Morganton, NC
Force Main
Erosion Control

FINAL DESIGN - 100%
RELEASED FOR
CONSTRUCTION

DATE: 05/04/23
SHEET **CE2.3**

Bost Rd Sewer Improveme
Morganton, NC
Force Main
Erosion Control

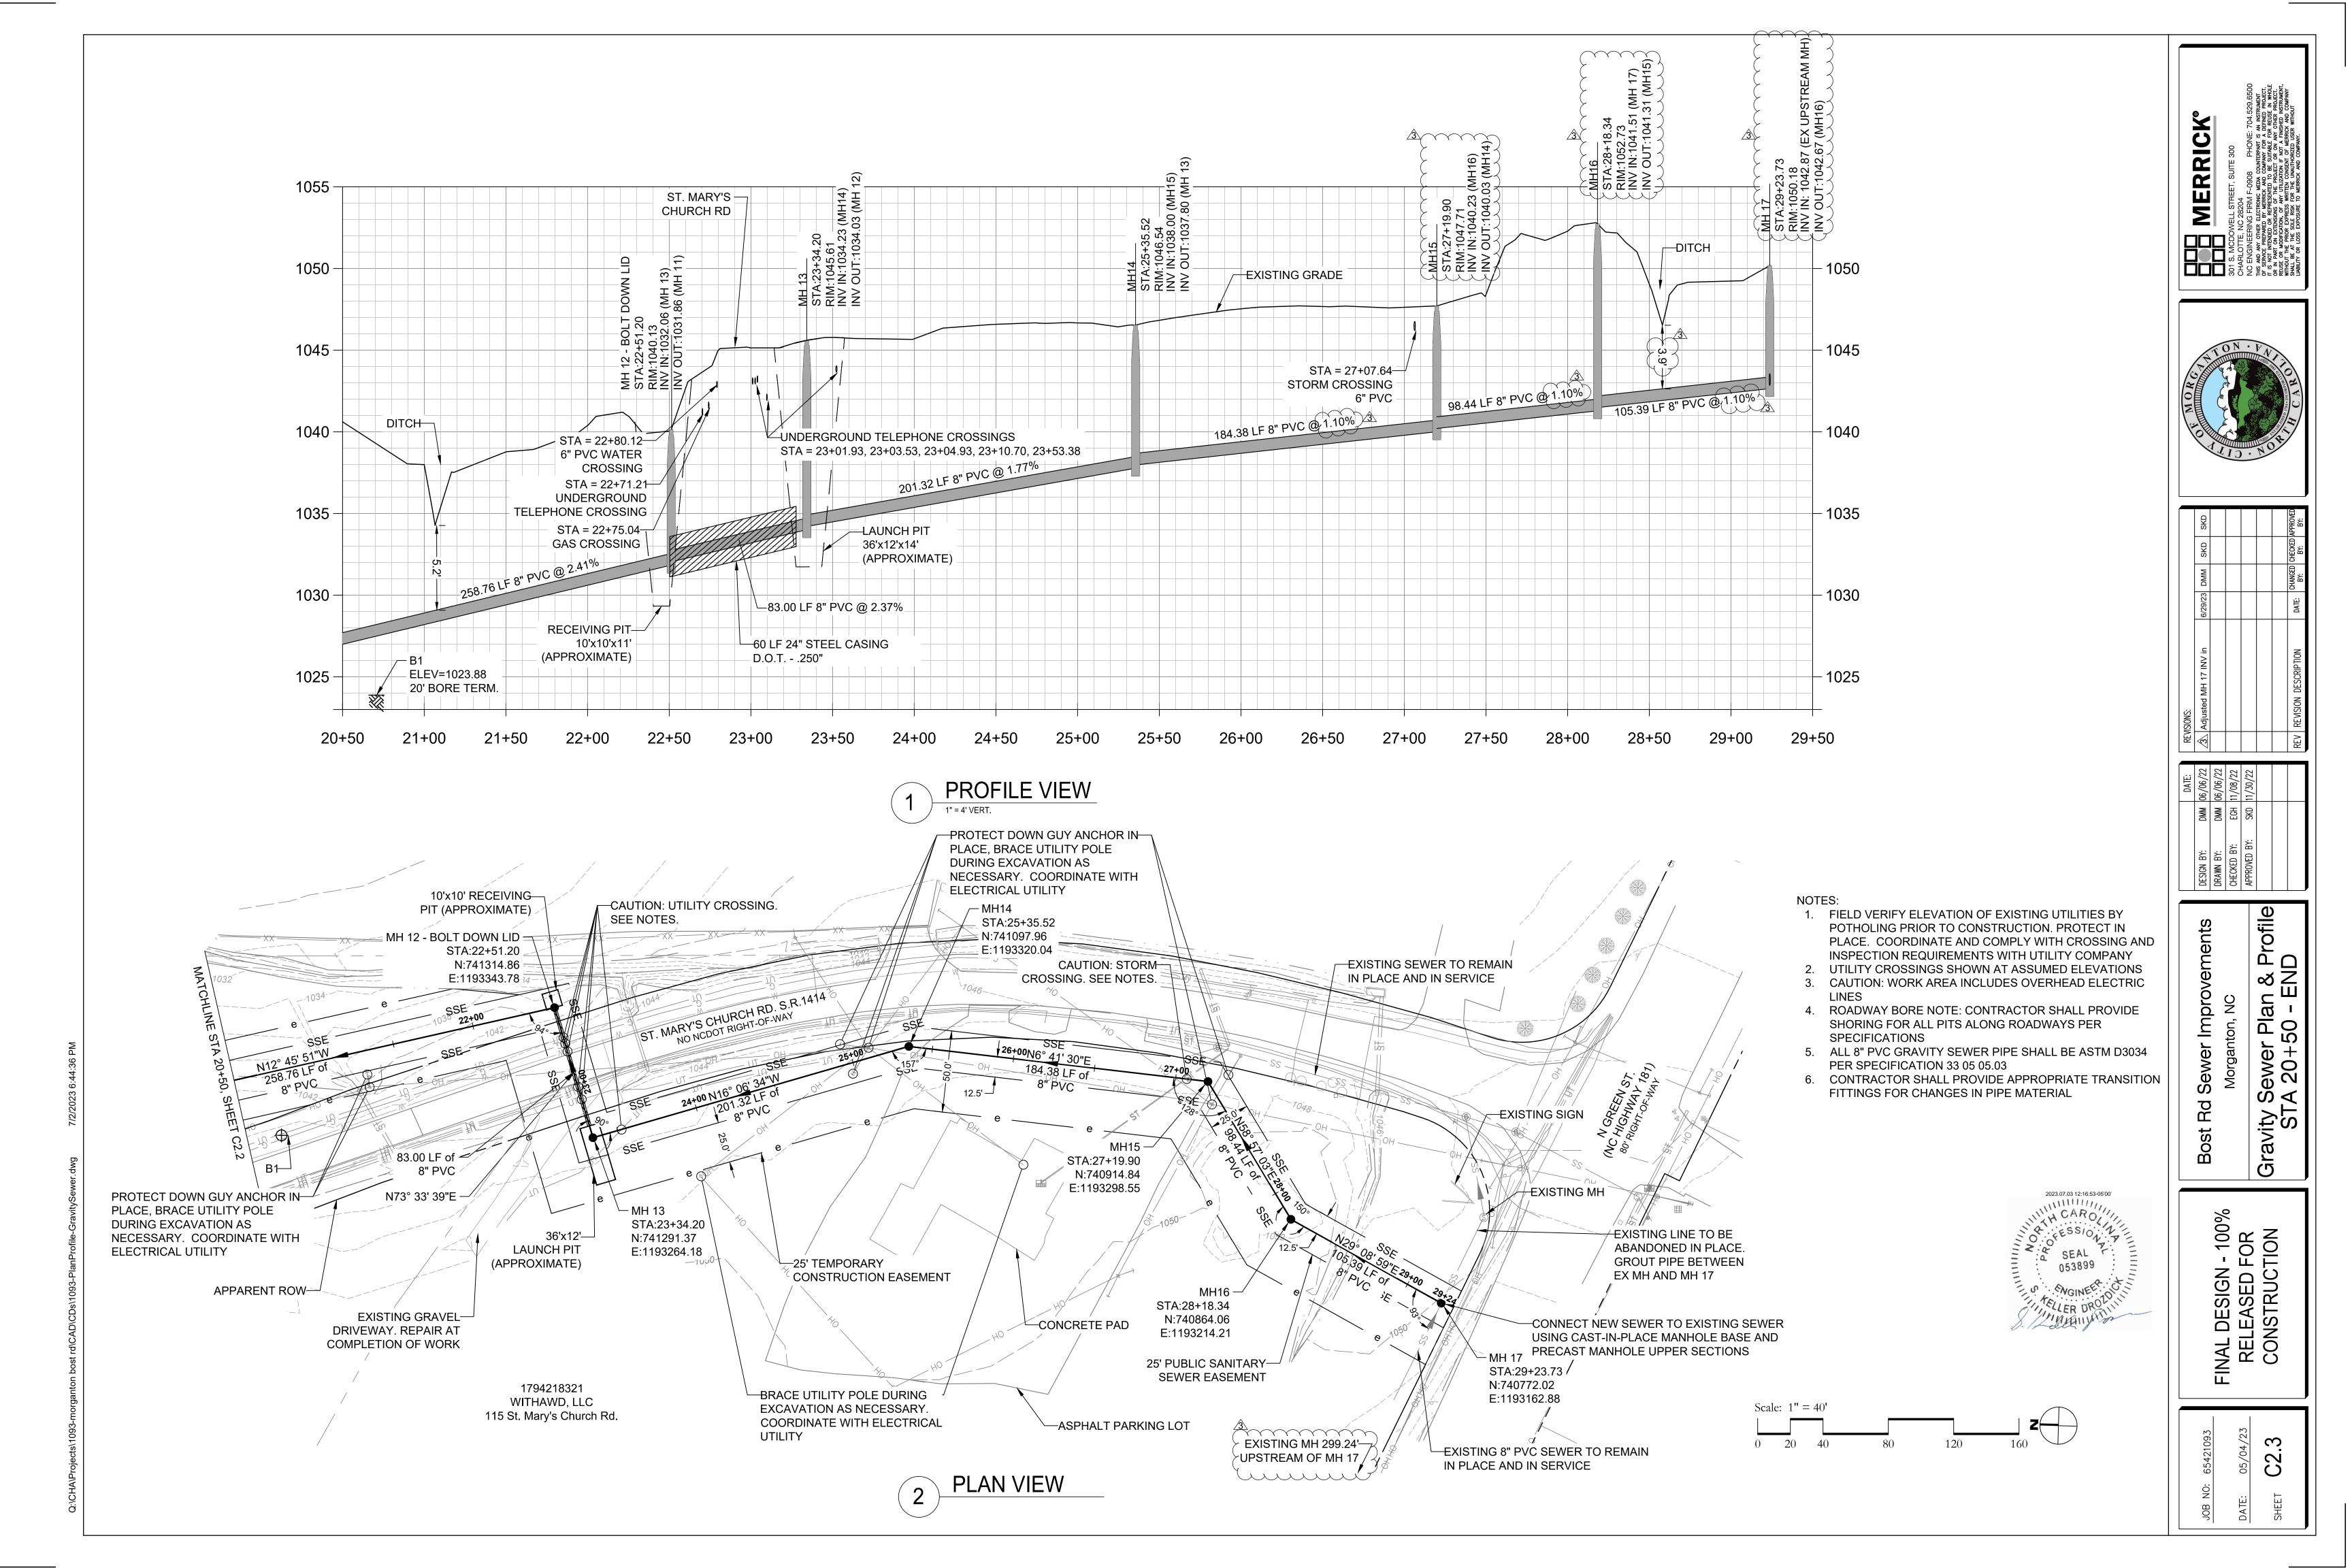
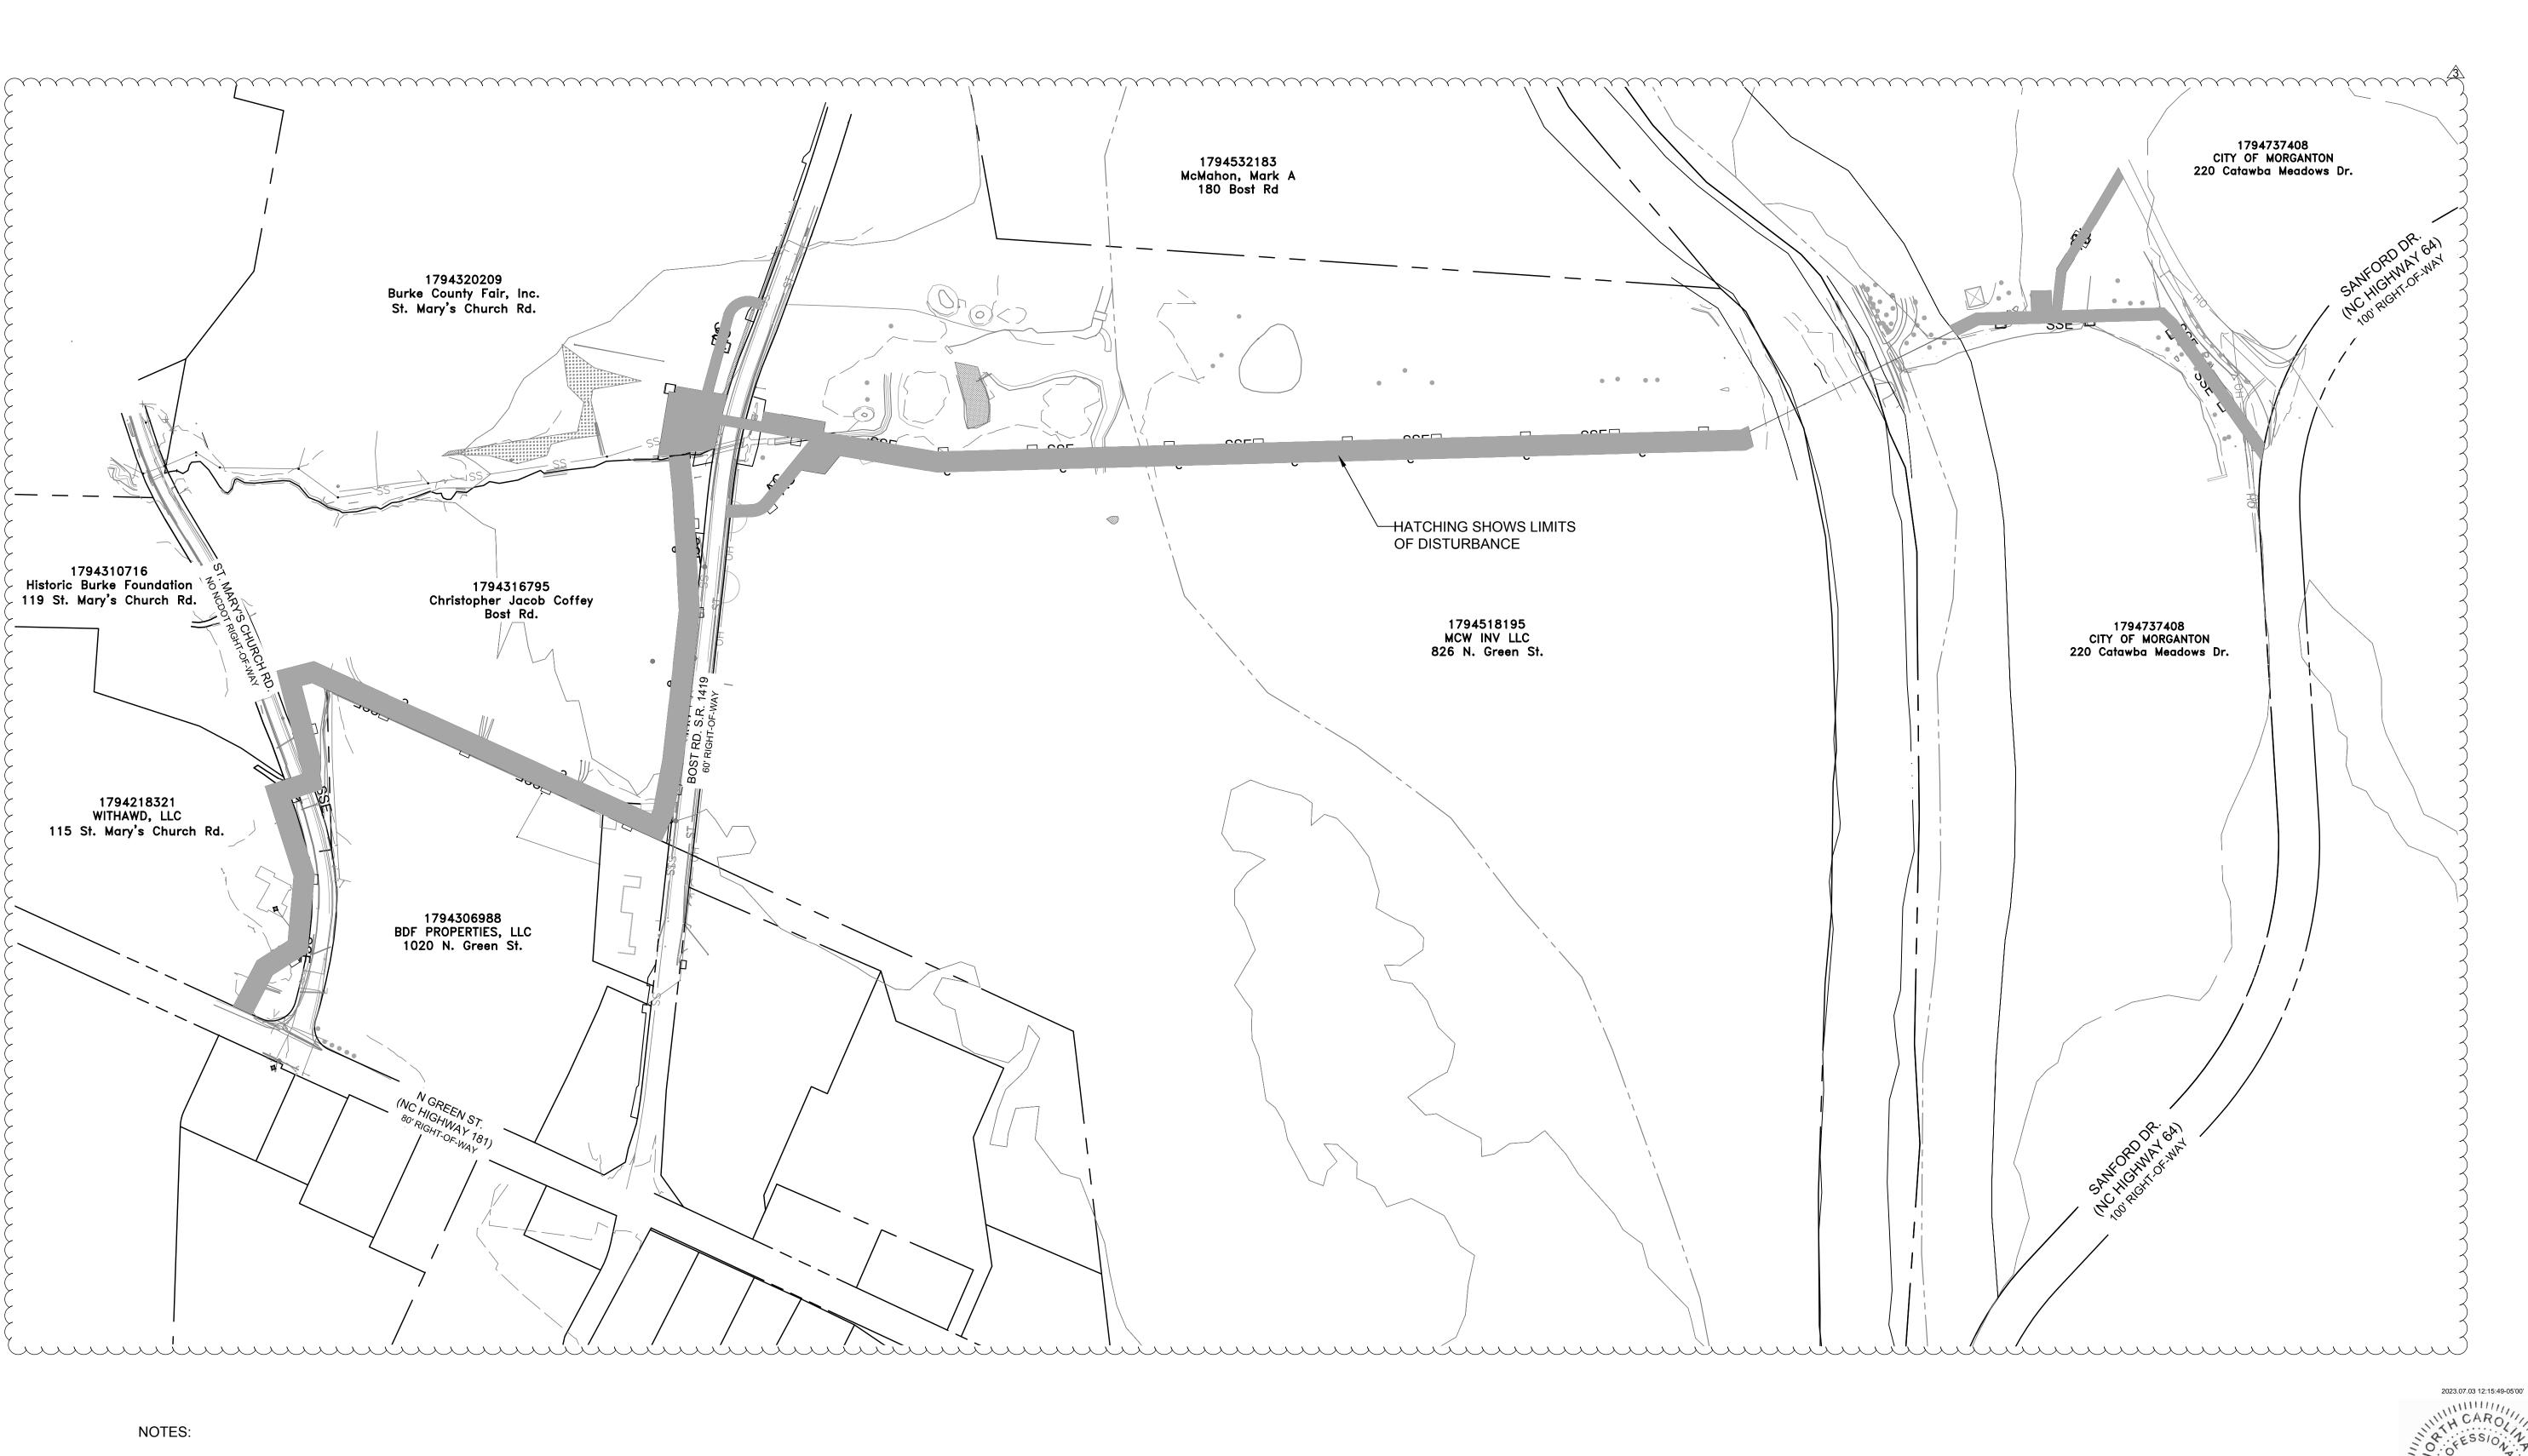
s a					KED APP (:
	SKD					CHECKE BY:
	7/3/23 DMM					CHANGED CHECKED APP BY: BY: I
	7/3/23					DATE:
REVISIONS:	Added permanent and temp. easement					REV REVISION DESCRIPTION
REV	<b>⊗</b>					REV
13.1	/22	/22	,22	'22
